**Agency of Natural Resources  
Department of Environmental Conservation**

**MEMORANDUM**

Subject: MAPP Reasonable Potential Determination for Shelburne FD#1 Crown Road Wastewater Treatment Facility (WWTF)

Shelburne FD#1 Crown Road WWTF  
Permit No. 3-1289  
NPDES No. VT0100331

**Figure 1. Approximate location of outfall pipe, relative to the Lake Champlain Long-term Biological and Chemical Monitoring Program station.**

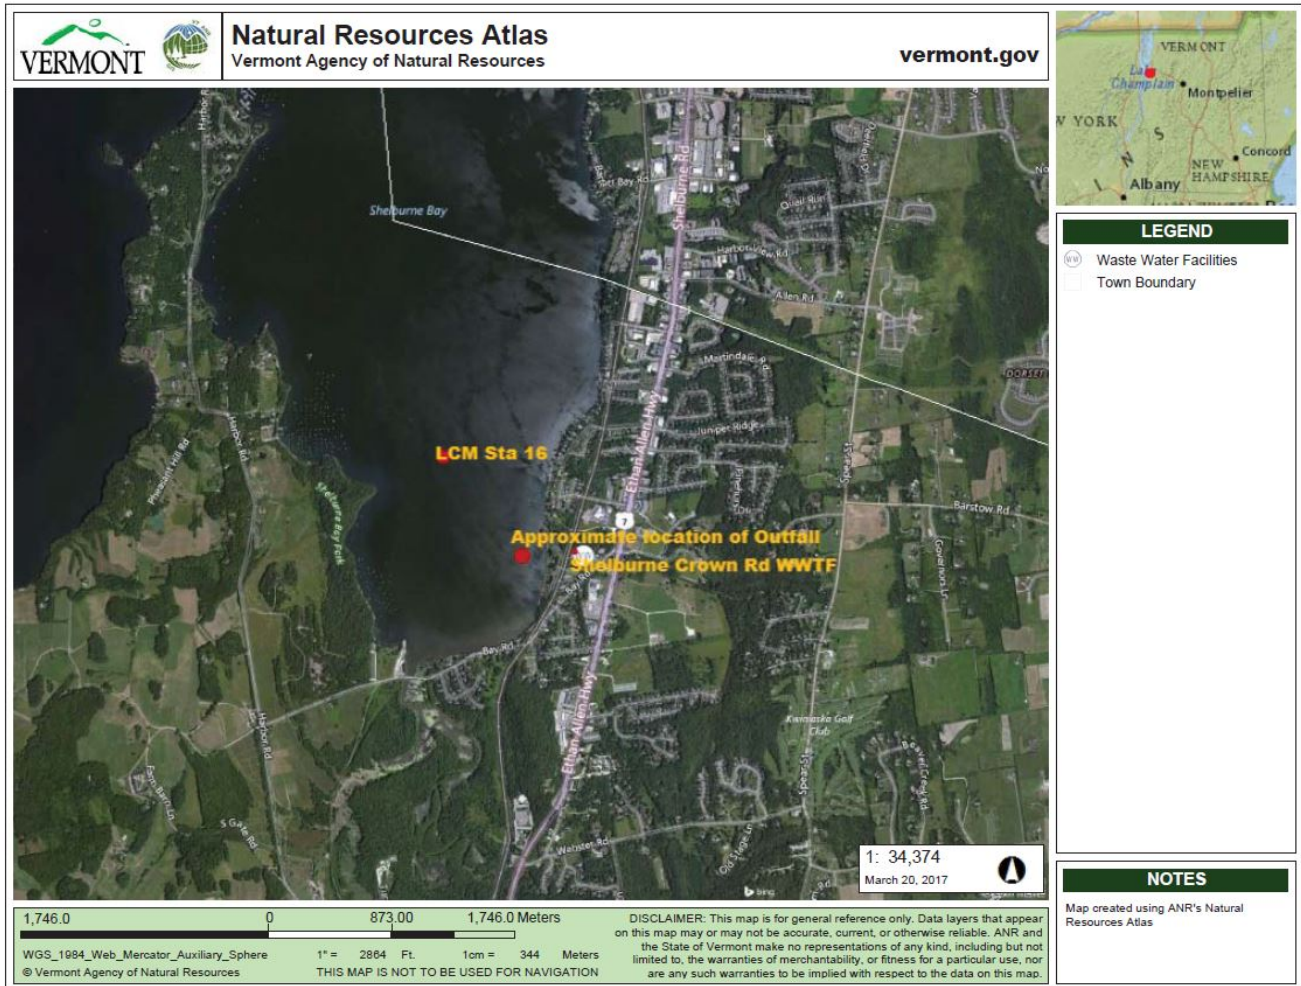
MAPP has evaluated the draft permit for the Shelburne Crown Road WWTF, in relation to available water quality monitoring data, to determine the protectiveness of the permit with respect to receiving water quality criteria. Figure 1 provides a graphical representation of the location of the outfall for this facility, relative to the most proximal location from which water quality monitoring data are available.

Figure 2. Long-term total phosphorus concentration monitored by the Lake Champlain Long-term Biological and Chemical Monitoring Program. Y-axis shows total phosphorus in ug/L.

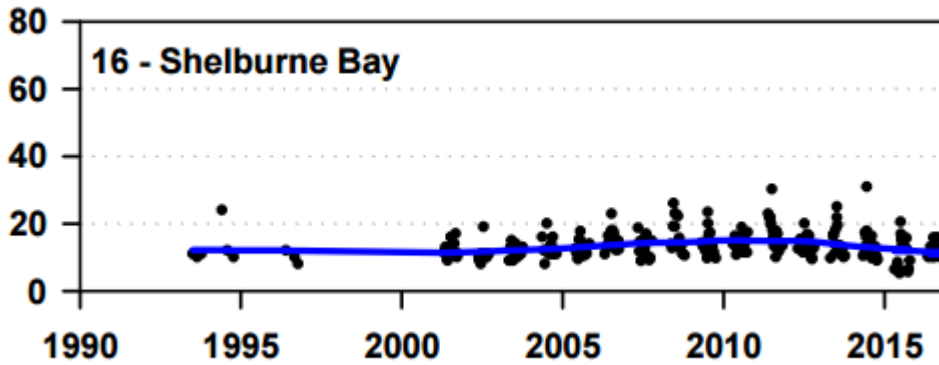
Lake Champlain Water quality monitoring data are available from the [Lake Champlain Long-term Biological and Chemical Monitoring Program](#), from a monitoring station located approximately 2,800 feet west by southwest of the outfall and mixing zone centroid. Results from this station indicate that total phosphorus concentrations in the Shelburne Bay segment for the period 2015-2016 averaged 12.2

ug/L, and that long-term trends suggest that the average concentration in this segment has been declining slightly since 2012 (Figure 2). Pursuant to the Vermont Water Quality Standards, this location is an appropriate location to determine compliance with the relevant water quality criterion for this segment.

Figure 3. Long-term total nitrogen concentration monitored by the Lake Champlain Long-term Biological and Chemical Monitoring Program. Y-axis shows total nitrogen in mg/L.

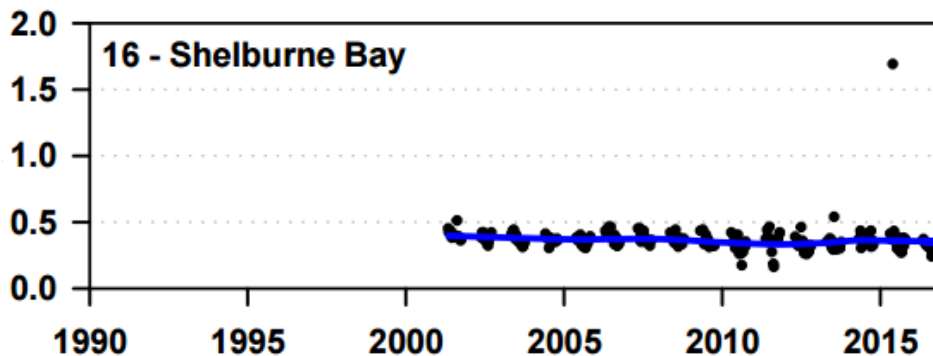
Water quality monitoring data available from the [Lake Champlain Long-term Biological and Chemical Monitoring Program](#) indicates that total nitrogen concentrations in the Shelburne Bay segment for the period 2015-2016 average 0.37 mg/L, and long-term trends suggest that the average concentration in this segment is flat to slightly declining over the period of record (Figure 3).
